Attachment 2 to AEP:NRC:0916AB
Proposed Revised Technical Specification Pages

3/4.1 REACTIVITY CONTROL SYSTEMS

3/4.1.1 BORATION CONTROL

D. C. COOK - UNIT 2

Figure 3.1-3 REQUIRED SHUTDOWN MARGIN

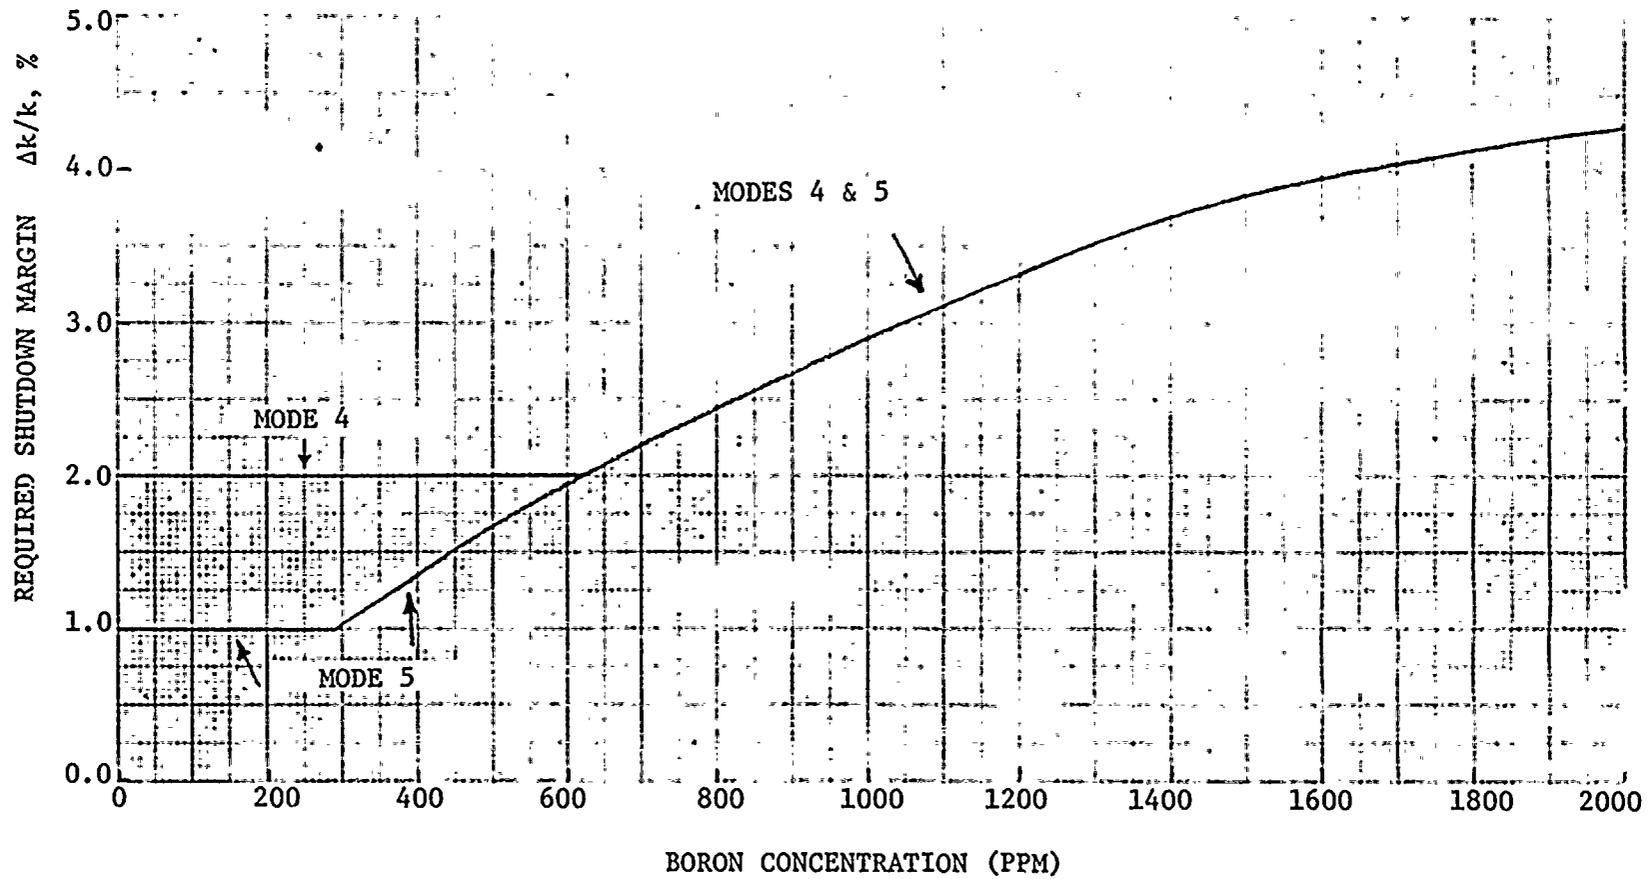
1. Greater than or equal to $2.0\% \Delta k/k$ when operating with one or more Reactor Coolant Loops in accordance with Specification 3.4.1.3.
2. Greater than the value shown in Figure 3.1-3 when operating with no Reactor Coolant Loops but one or more Residual Heat Removal Loops in accordance with Specification 3.4.1.3.

1. Greater than or equal to $1.0\% \Delta k/k$ when operating with one or more Reactor Coolant Loops in accordance with Specification 3.4.1.3.
2. Greater than the value shown in Figure 3.1-3 when operating with no Reactor Coolant Loops but one or more Residual Heat Removal Loops in accordance with Specification 3.4.1.3.
